**ADDENDUM 1**

**ADDENDUM DATE:** April 8, 2022

**PROJECT:** Northgate Complex Renovation  
1509 N. Fayetteville Street  
Asheboro, NC 27203

**5**  
**A5-01** **METAL PANEL SILL - SECTION DETAIL**  
**1 1/2" = 1'-0"**

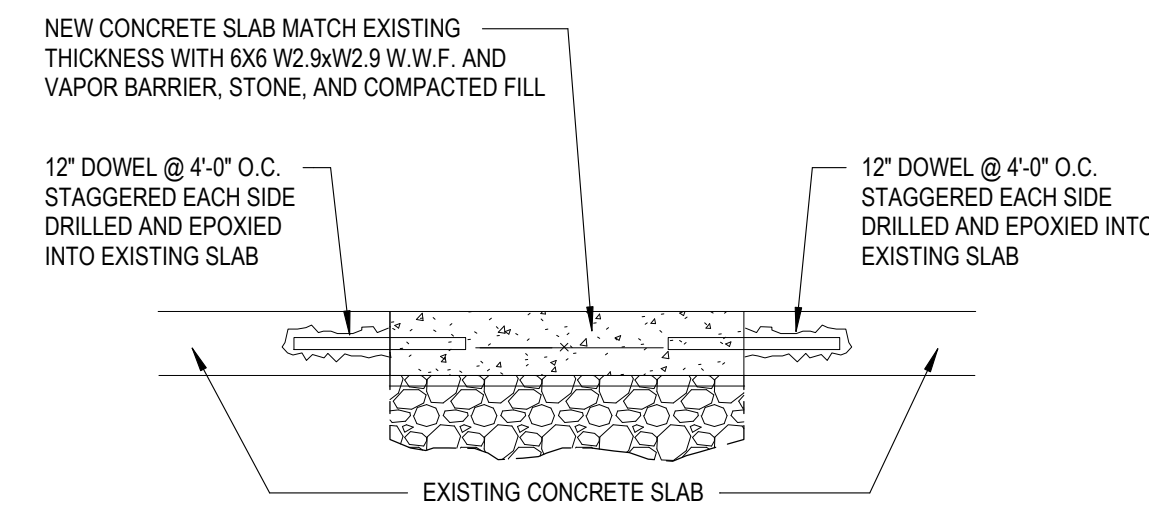
1. **CLARIFICATION:** Sheet A0-03 Demo Elevations: Drawing 2/A0-03, note that Demo of metal canopy, panel, and cladding also consists of removing the existing signage attached to these panels. Electrical shall also be completely removed to these signs.
2. **REVISION:** Sheet A4-10 Casework Elevations and Details: Replace Sheet A4-10 in its entirety with the attached Sheet A4-10.
3. **REVISION:** Sheet A5-01 Details: Replace Sheet A5-01 in its entirety with the attached Sheet A5-01. Note, Detail 5/A5-01 has been added.

5 TYP. EXTERIOR DOOR THRESHOLD - T3  
A6-01 1 1/2" = 1'-0"

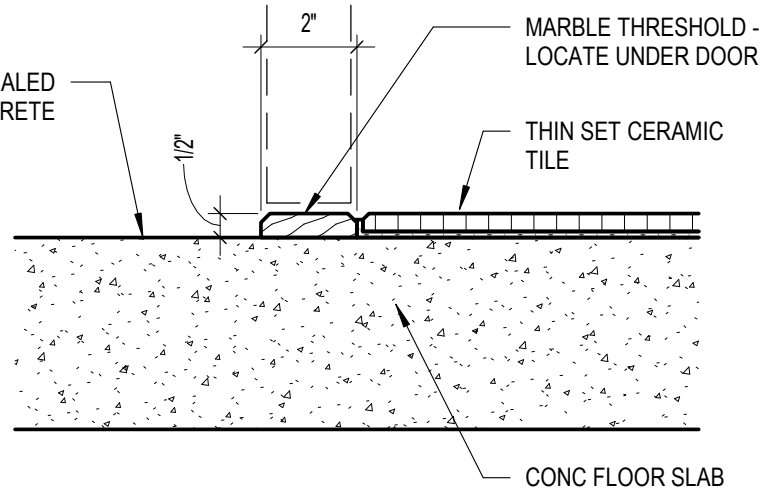
4. **REVISION:** Sheet A6-01 Door Schedule: Replace Sheet A6-01 in its entirety with the attached Sheet A6-01. Note, Detail 5/A6-01 has been updated and Door 721 has been changed to Hollow Metal.

**6**  
**A6-02** **TYP. STOREFRONT SILL AT SLAB**  
1 1/2" = 1'-0"

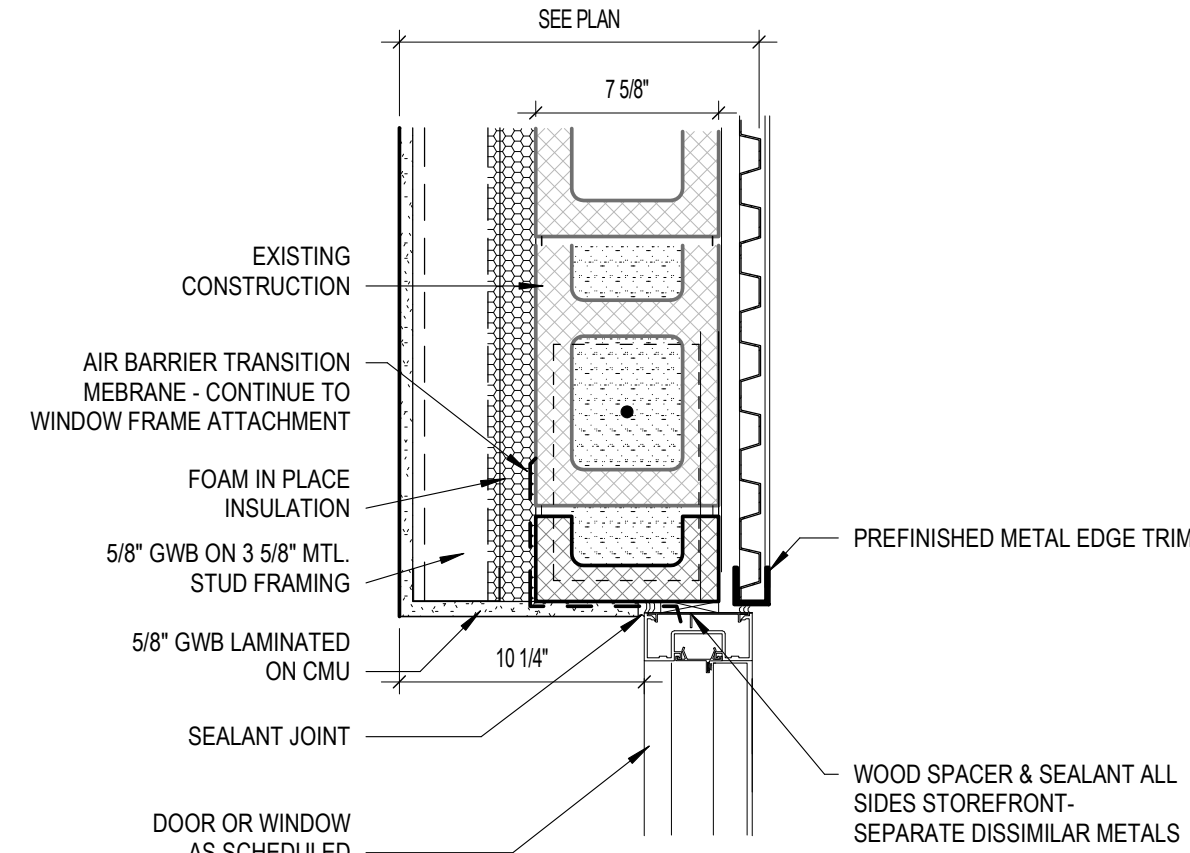
5. **REVISION:** Sheet A6-02 Window and Frame Elevations: Replace Sheet A6-02 in its entirety with the attached Sheet A6-02. Note, Detail 6/A6-02 has been updated.
